Product Change Notification: E-20-014948

PRODUCT GROUP DRAWING FOR JUNIOR POWER TIMER CONTACT

Drawings are Updated for the following affected items (PNs 2367105-6, 2367105-3, 2367105-1 and 927768-8 are added in the Table)

Picture:

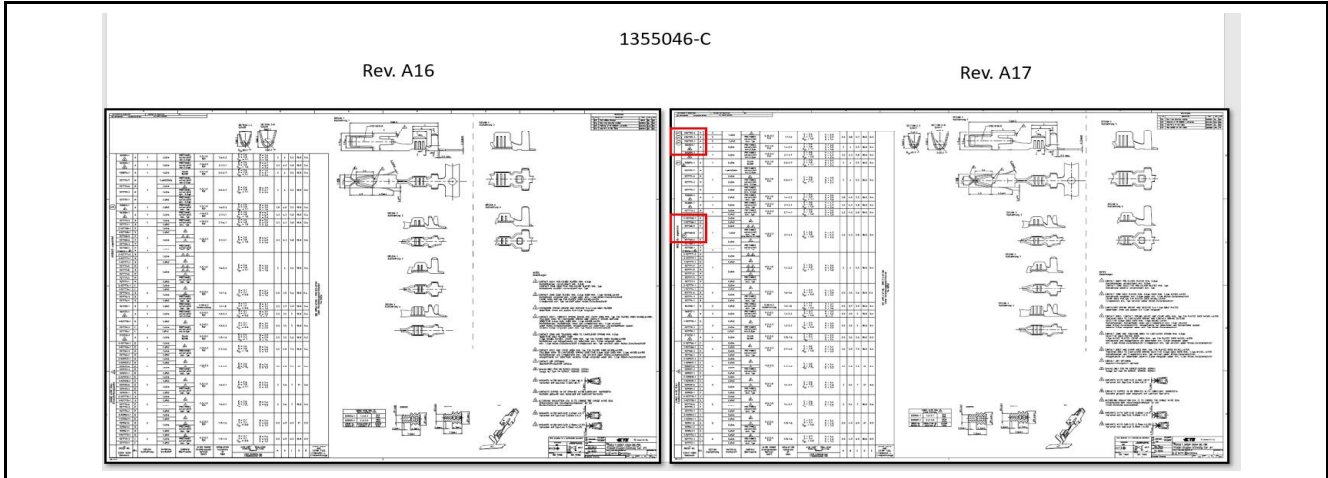
<input checked="" type="checkbox"/> Potential Impact for Customer	<input checked="" type="checkbox"/> Product Type	<input checked="" type="checkbox"/> Change Type	<input checked="" type="checkbox"/> Kind of Change	<input checked="" type="checkbox"/> Change Feature	Remark / Free text
	<input checked="" type="checkbox"/> TERMINALS	<input checked="" type="checkbox"/> No Form, Fit, Function	<input checked="" type="checkbox"/> Drawing	<input checked="" type="checkbox"/> Drawing Change	PNs 2367105-6, 2367105-3, 2367105-1 and 927768-8 are added in the Table
